**Case No. 2006.1073E**

# **THE EXPLORATORIUM RELOCATION PROJECT**

## **COMMENTS AND RESPONSES**

**DATE:** June 25, 2009  
**TO:** Members of the Planning Commission and Interested Parties  
**FROM:** Bill Wycko, Environmental Review Officer  
**RE:** Case No. 2006.1073E, Exploratorium Relocation Project  
Comments and Responses on the DEIR

THE EXPLORATORIUM RELOCATION PROJECT  
FIGURE C&R 7: PROJECT - EAST AND WEST ELEVATIONS

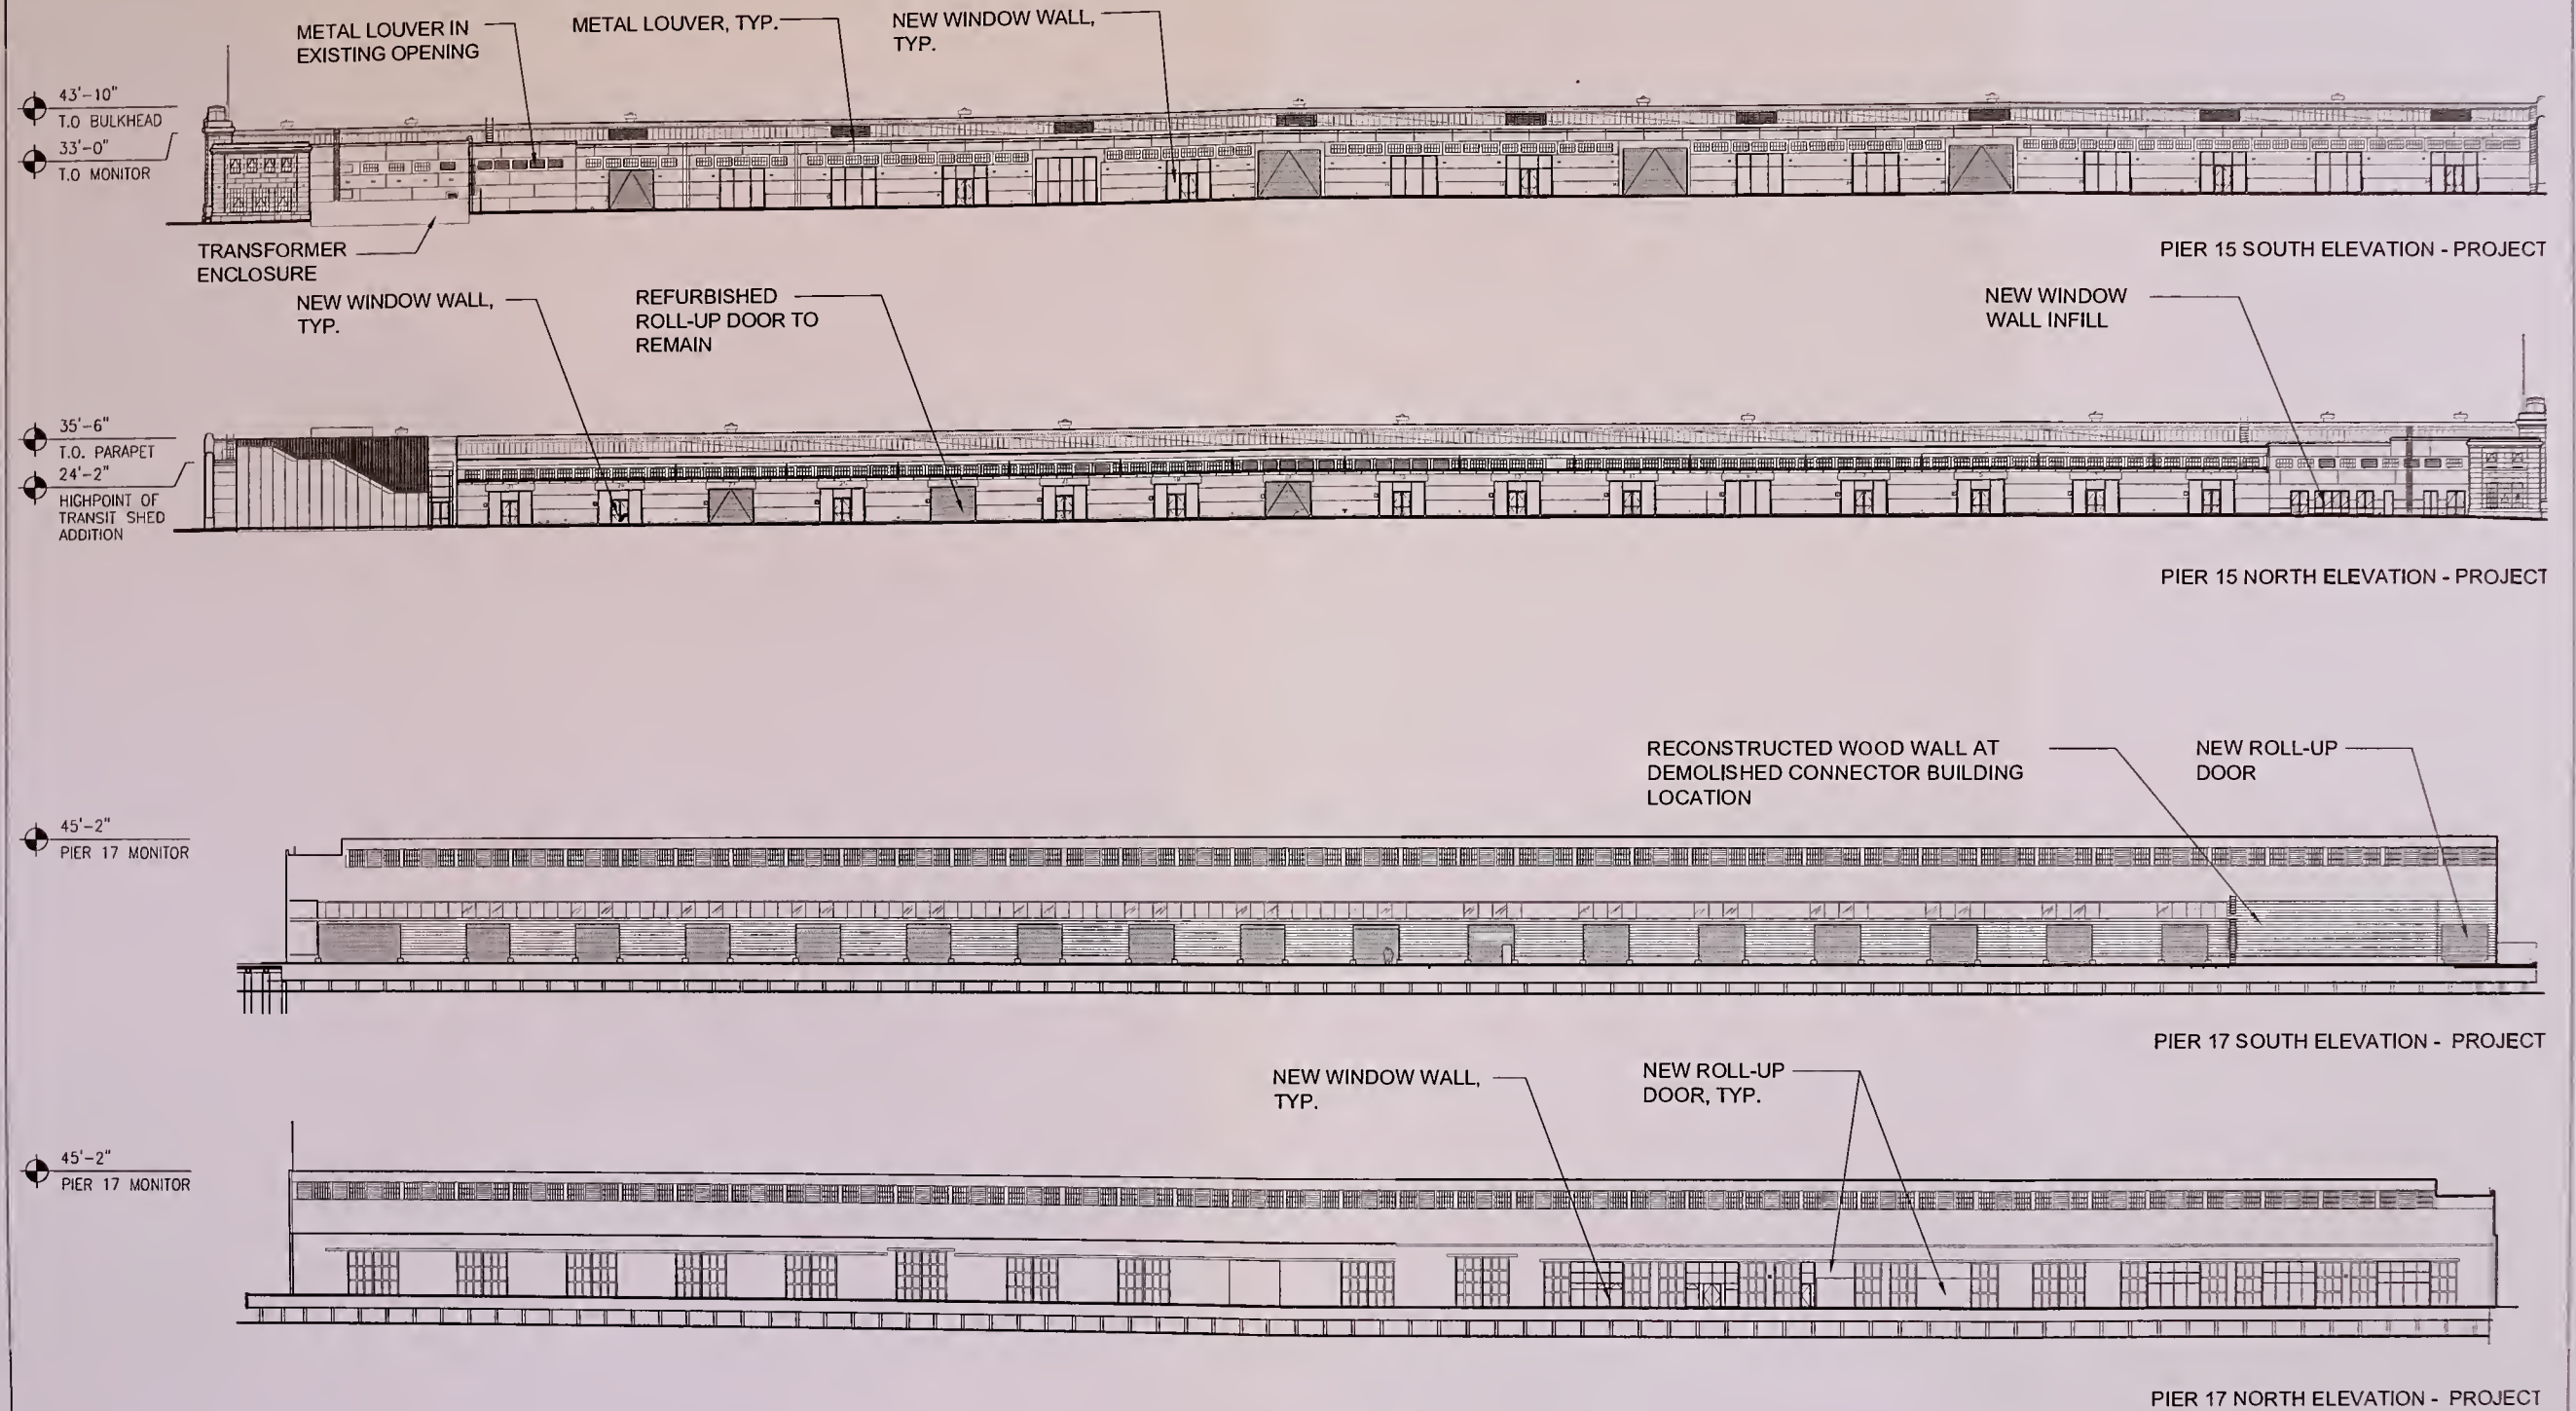
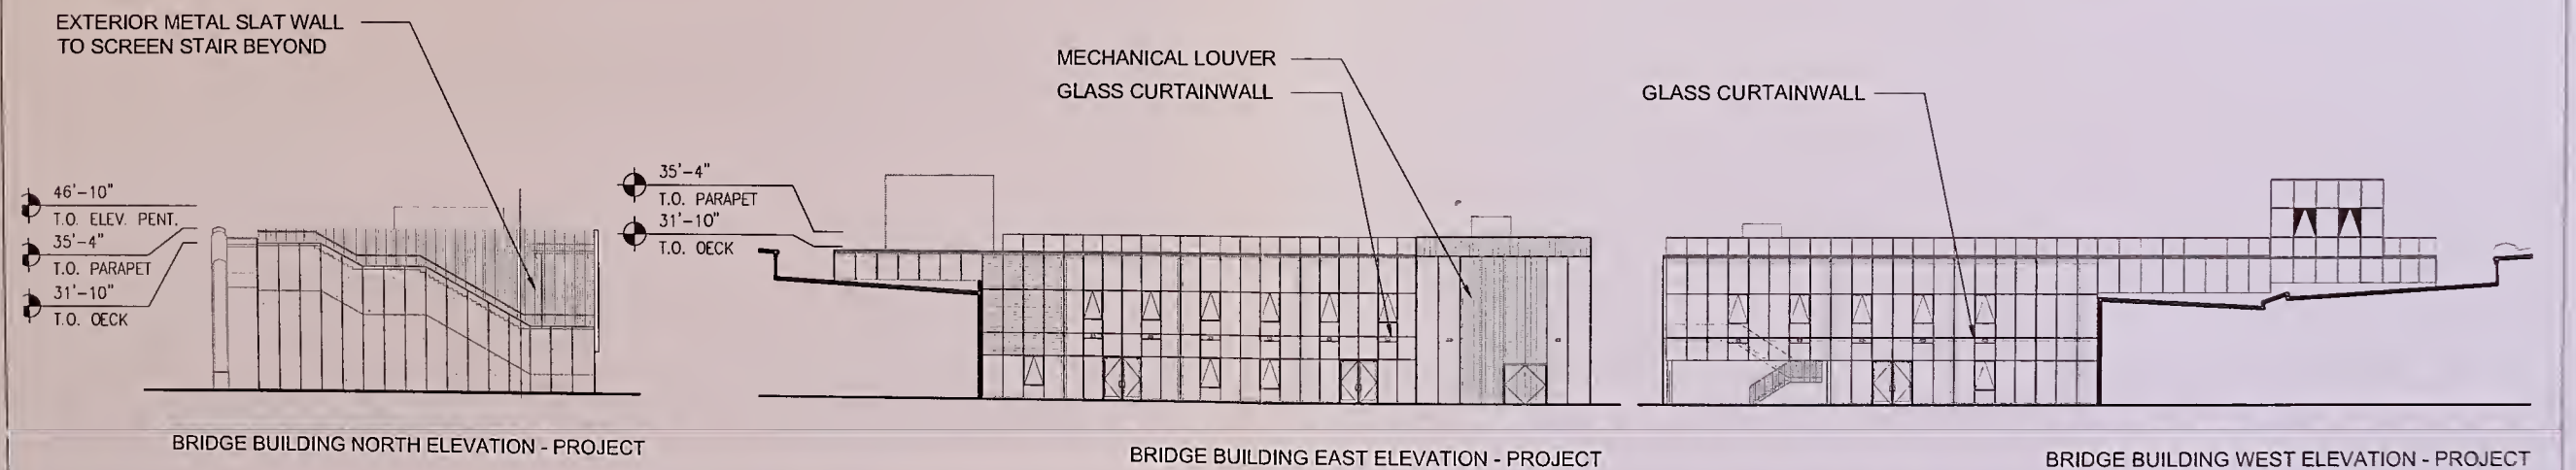
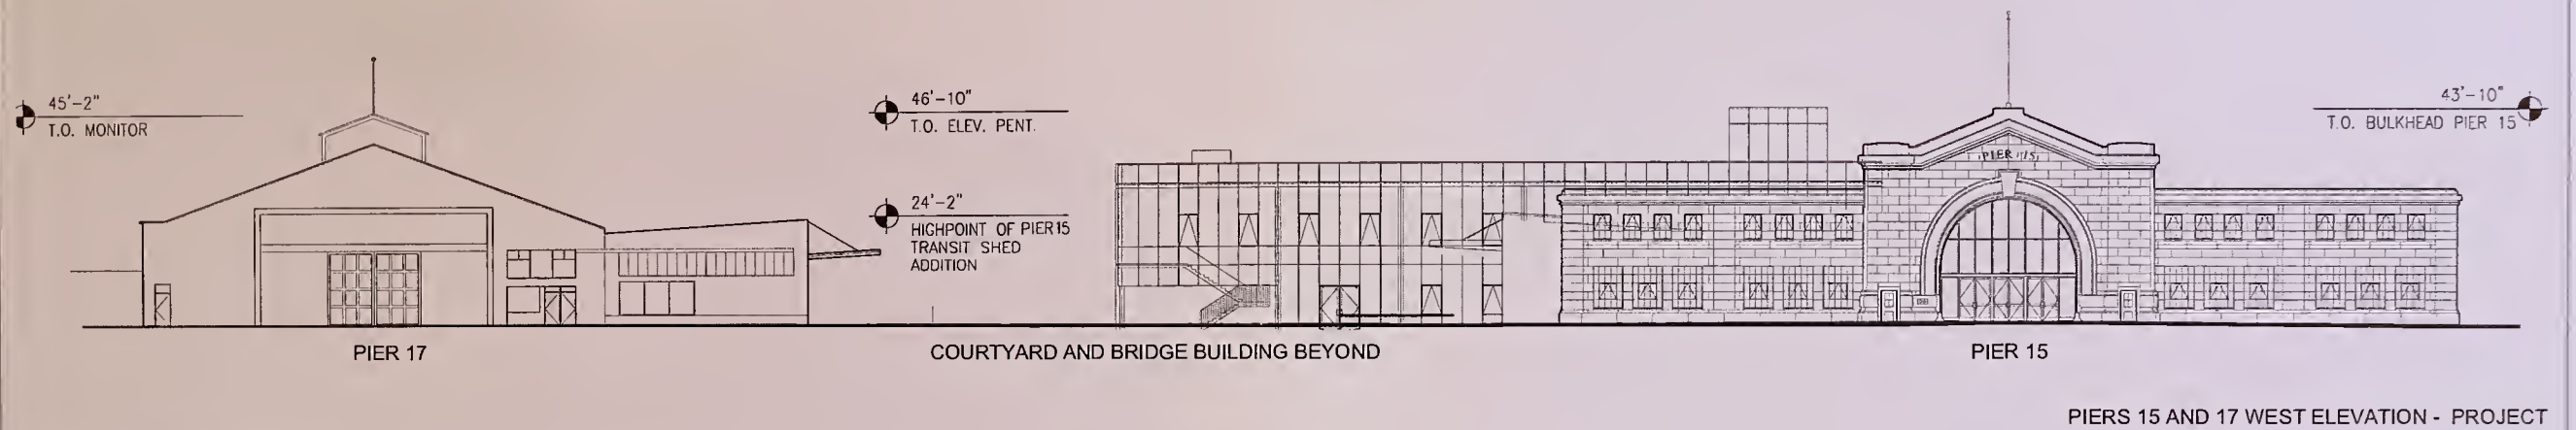
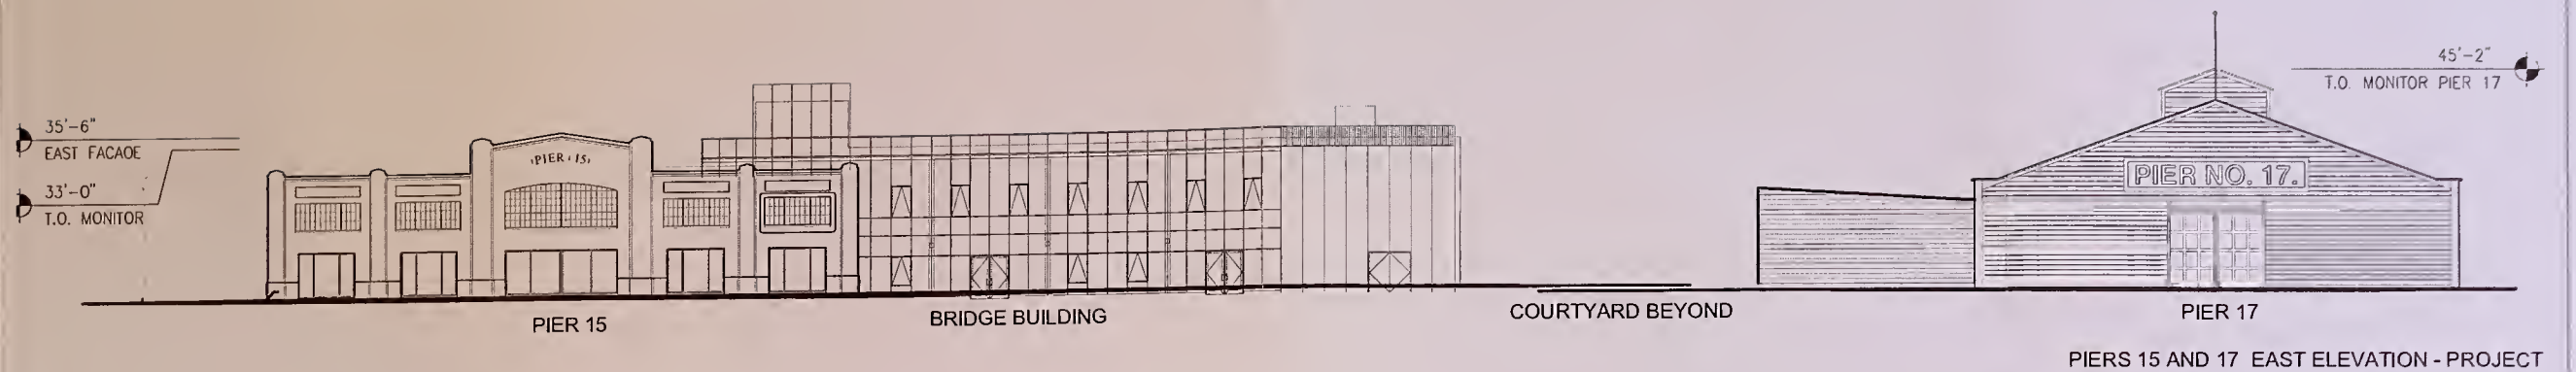
The proposed new Bridge Building is not adequately depicted nor fully described in the DEIR. The Draft EIR fails to adequately describe and depict the proposed new Bridge Building. There are no detailed drawings of this proposed new structure in the DEIR clearly showing the materials, architectural details or scaled height measurements in comparison to the existing historic sheds. The elevations are so pale as to not be readable (Figure 5) or they specifically state that the elevations are “not to scale” (Figure II-15). The photomontages contained at III.C-15 do not adequately show the proposed new Bridge Building and, because of the wide-angle lenses used for the basic image, these images are misleading and not at all informative. This appears to be a serious inadequacy of the DEIR. Without separate detailed presentations, there is no way the public or decision-makers could understand the potential impacts that the design of this building could have on historic resources and the aesthetics of our Waterfront. (*Vedica Puri, Telegraph Hill Dwellers, February 25, 2009*)

For the proposed new bridge building, there are no detailed drawings in the DEIR which clearly show the architectural detail or scaled height measurements in comparison to proposed sheds. (*Andy Katz, March 5, 2009*)

The commentors believe that the DEIR does not contain adequate graphics that accurately depict components of the Project and Expanded Project. The Project Description graphics have been revised to present details of the Project and Expanded Project more clearly. Additional graphics have also been included to illustrate the floor plans and building elevations for the Project and Expanded Project. The revised Project Description graphics are presented in Figures C&R-3 through C&R-10 on pp. C&R-35 through C&R-45 of this Comments and Responses document. These Figures will replace Figure II-3 through II-5 of the DEIR. Additional simulations of the Project and Expanded Project have been prepared to depict the Bridge Building as viewed from Herb Caen Way and the San Francisco Bay. Figure C&R-11, p. C&R-47 illustrates the locations of the new viewpoints and replaces Figure III.C-1, p. III.C-4 of the DEIR.

The note "not to scale" is a standard architectural term to alert the viewer that a physical architectural ruler (or scale) may not be used to measure building dimensions. However, the figures are accurately depicted relative to other elements within the drawing. The additional and revised graphics have clearer elevation marks depicting heights.

THE EXPLORATORIUM RELOCATION PROJECT  
FIGURE C&R 9: EXPANDED PROJECT - EAST AND WEST ELEVATIONS

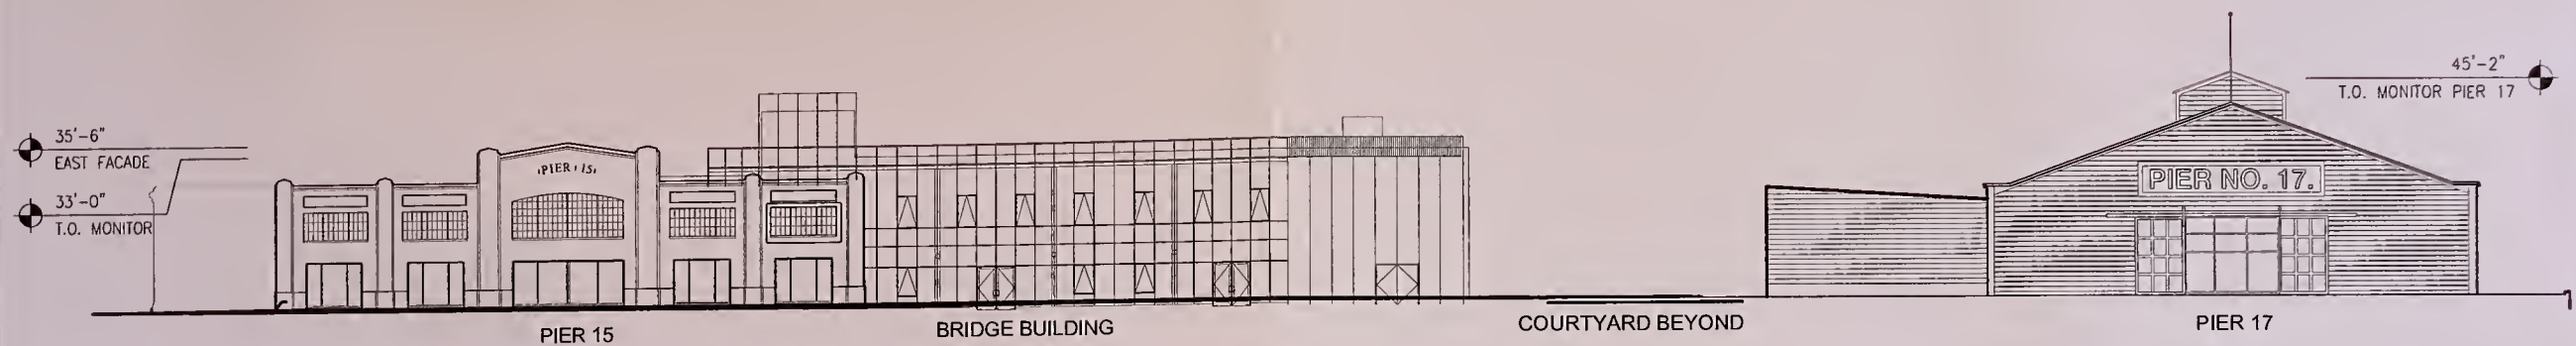
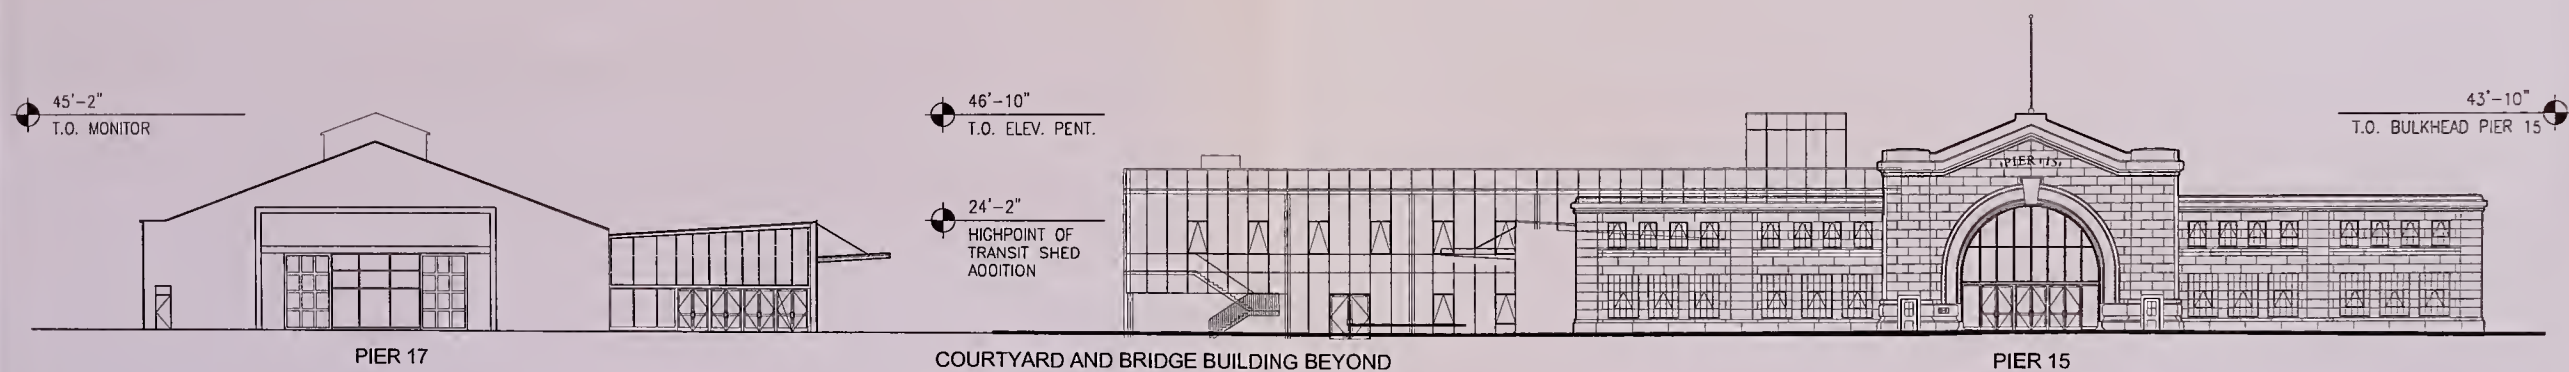
Just to comment, I think the DEIR itself is woefully inadequate in terms of its graphics. How we can make a conclusion that the connector building is sort of okay and arrive at some mitigation measures, at least on what's on the published document, I don't see how we can reach those conclusions. And perhaps some better graphics would assist the public in doing so. (*Commissioner Sugaya, March 5, 2009*)
